SERVICE LETTER

No. 400

SUBJECT: Tail Brace Rods

MODELS AFFECTED: All PA-12, PA-14 and PA-20 Aircraft and
PA-22 Tri-Pacer Aircraft Serial Nos. 22-1 to 22-7999 incl.

STABILIZED TIE ROD ATTACHMENT

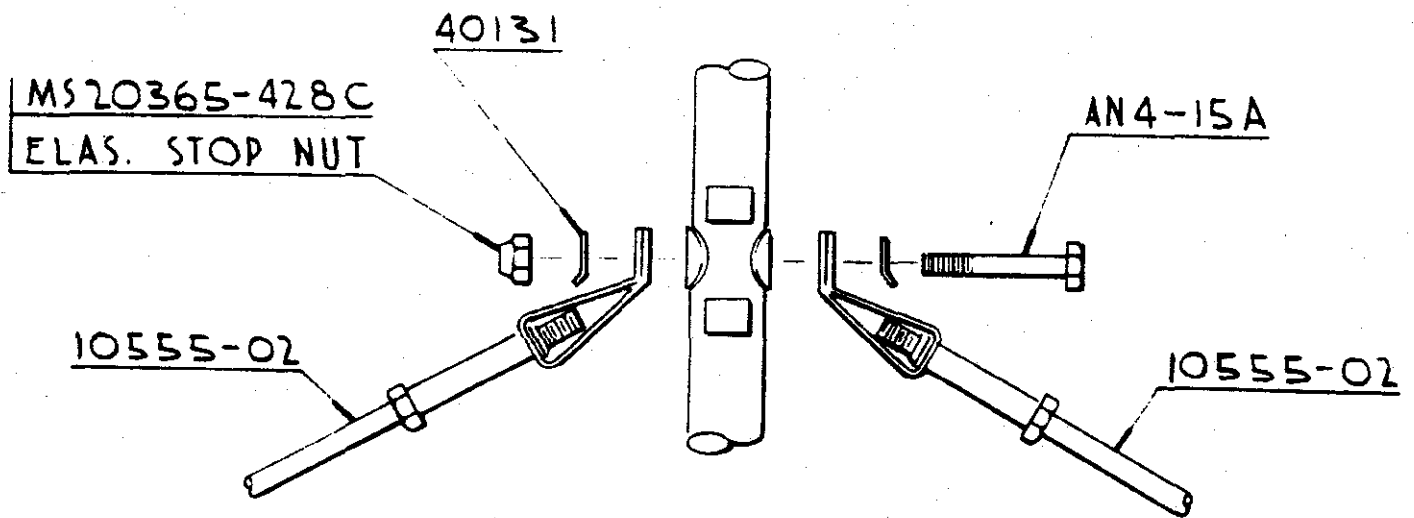
We wish to announce that the round upper and lower tail brace tie rod assemblies, part numbers 10555-02 and 10556-02, respectively, have been approved to replace the upper and lower streamline tail brace tie rod assemblies, part numbers 10074-02 and 10074-03, on PA-12, PA-14, PA-20 and PA-22 aircraft, serial numbers listed above.

The installation of the round tail brace tie rods will eliminate compliance with Piper Service Bulletin No. 183 and F.A.A. AD-60-1-7. Therefore, it is recommended that as the streamline tie rods are retired from service, the round tie rods be installed as a replacement. See Sketch on reverse side for complete details.

NOTE - SECURE ATTACHMENT PARTS AS SHOWN TO COMPLY WITH THIS SERVICE LETTER.
